20th December 2017

2017/6500/P - 28 HARLEY ROAD LONDON, NW3 3BN - OBJECTION LETTER FROM No. 26 HARLEY ROAD

Proposed rear elevation drawing and a photograph of the rear elevation of 28 Harley Road

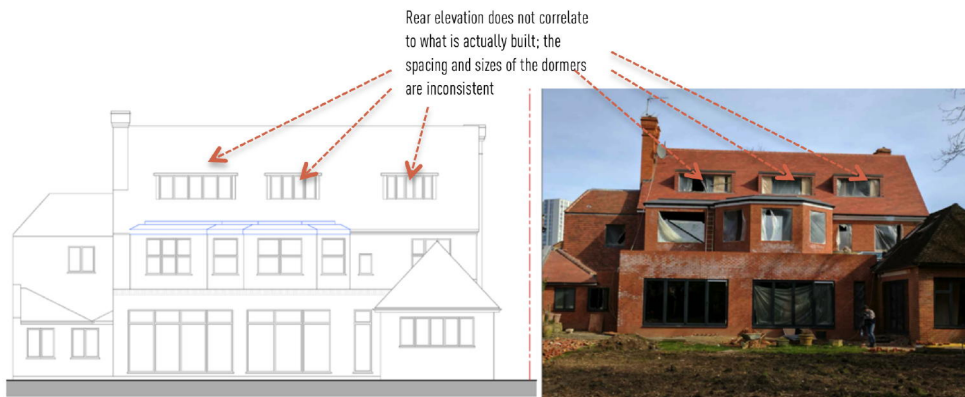
5. The dormer sizes and locations on the proposed drawings do not represent what has been built. The drawings should represent the construction. (Please refer to the image at the foot of this letter).

6. Similarly, there is a lantern roof-light that has been built on the rear elevation (Please refer to the image at the foot of this letter) that is not shown on the drawings. This poses the question of the reliability of the drawings and raised concern that there are other such omissions and inaccuracies that are not consent and could cause a detrimental impact to the setting of the conservation area and/or amenity of neighbours.

Newly built lantern
roof-light not
consented and not
indicated on the
proposed drawings

Rear elevation does not correlate
to what is actually built; the
spacing and sizes of the dormers
are inconsistent
